Vermont Agency of Transportation
RECEIVED
 CK'D BY TM, JW, NVDB, KM, RK OK'D BY JG
 April 12, 2017
 RESUBMIT No Approved AsNoted
 BY K. Higgins DATE 04/13/17

CALDERWOOD ENGINEERING, ETC.
 STRUCTURAL ENGINEERING • DETAILING SERVICES
 222 RIVER RD., RICHMOND, ME 04357 PH/FX (207) 737-2007 / 737-2008
 PREPARED FOR: MILLER CONSTRUCTION
 STRAFFORD BF 01777(10)

STRAFFORD VERMONT
 ABUTMENT SHOP DETAILS
 PBU-1 DIMENSIONAL DETAILS

BQT. OF DECK SLAB TABLE - PBU-1

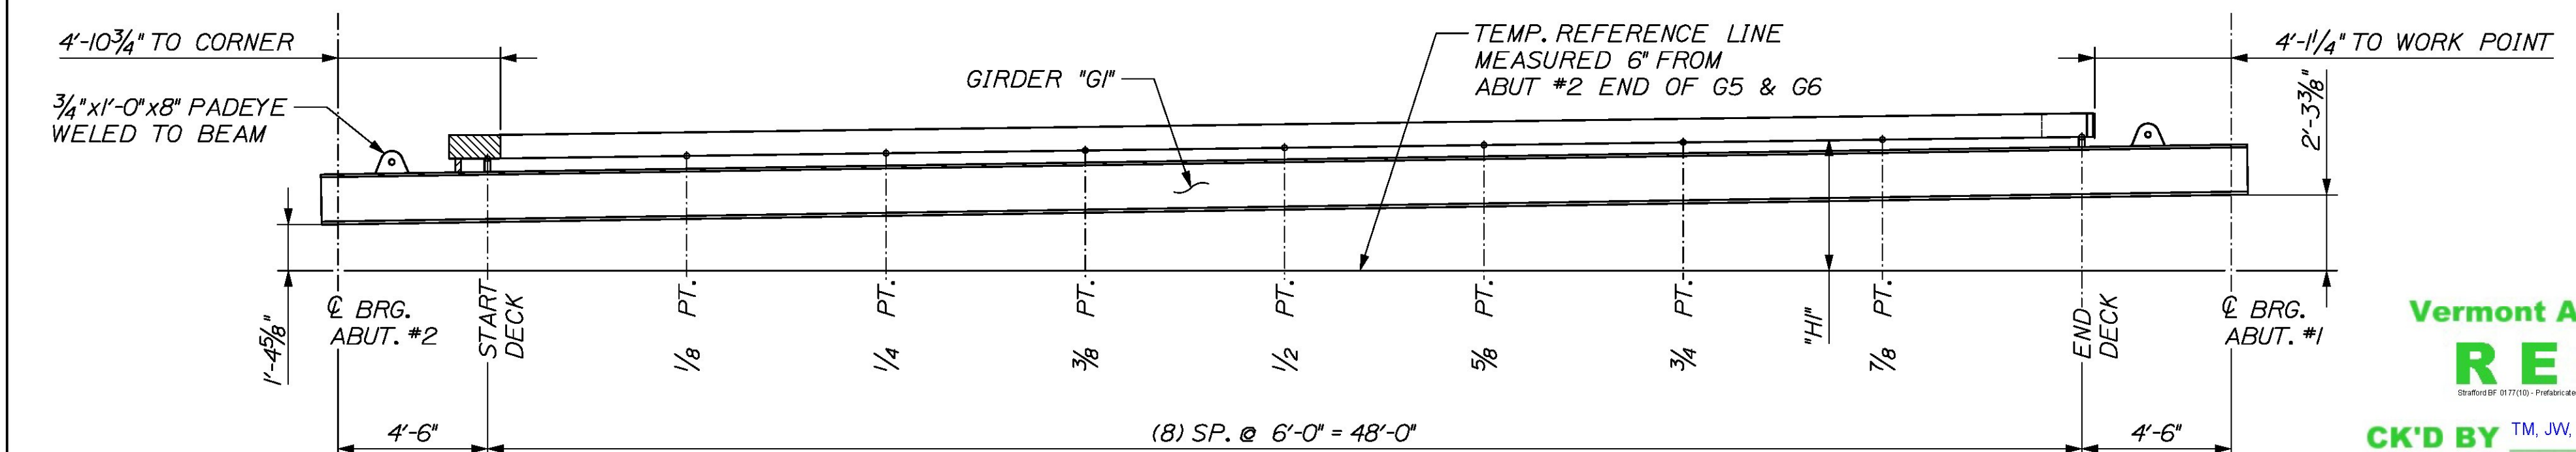
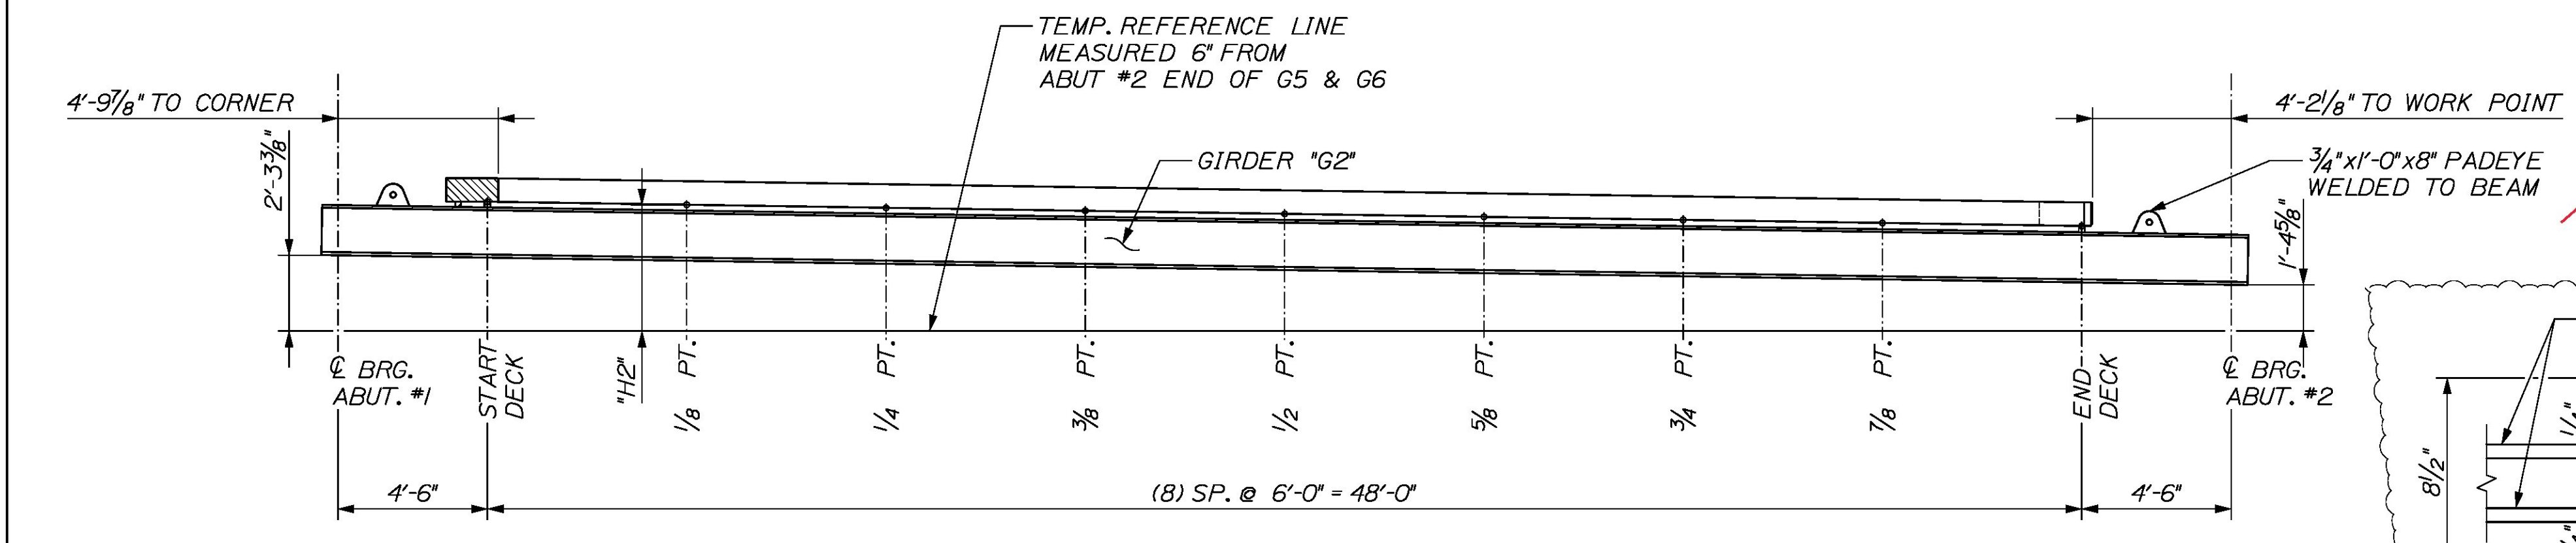
This information is unnecessary as Beam Profiles will need to be submitted prior to forming.
